FEDERAL COMMUNICATIONS COMMISSION
445 12th STREET SW
WASHINGTON DC 20554

Re: Bott Communications, Inc.
WCRT(AM), Donelson, TN
Facility Identification Number: 25031
File Number: BP-20100126AEA

This letter refers to the above-captioned application for a minor modification of station WCRT, Donelson, Tennessee to increase daytime antenna input power.

LOWER LEFT COORDS:	DATE: 5-APR-10
N. LAT.: 31 00 00	ENGINEER: JSK
W. LONG.: 94 00 00	JOB ID. WCRT

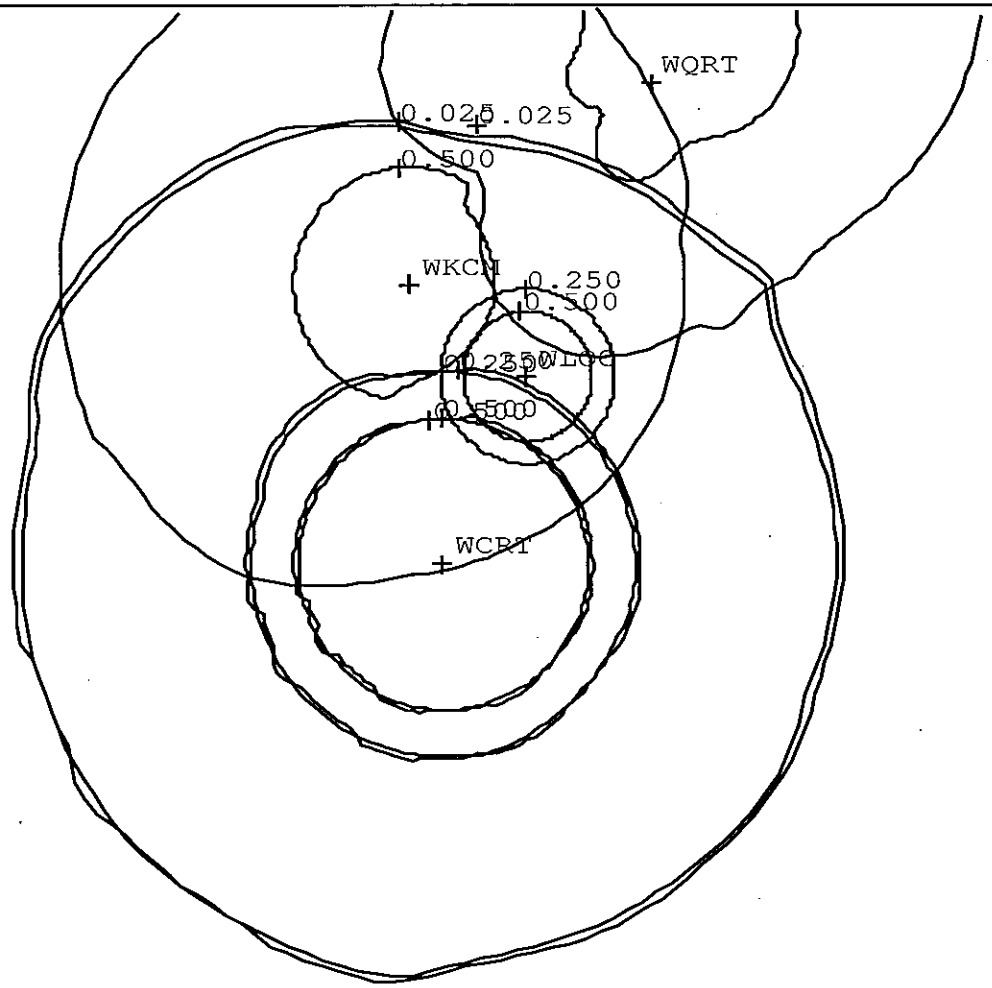
An engineering review of the application reveals that the proposed daytime operation would increase groundwave contours overlap to co-channel stations WKCM(AM), Hawesville, Kentucky, WQRT(AM), Florence, Kentucky, and first-adjacent channel station WLOC(AM), Munfordville, Kentucky, in violation of 47 CFR § 73.37(a). (See attached exhibit).

Accordingly, further action on the subject application will be withheld for a period of thirty (30) days from the date of this letter to provide you an opportunity to submit an amendment. Failure to amend or respond within this time period will result in the dismissal of the application pursuant to Section 73.3568. Please note that any amendment must be submitted in the same manner as the original application.
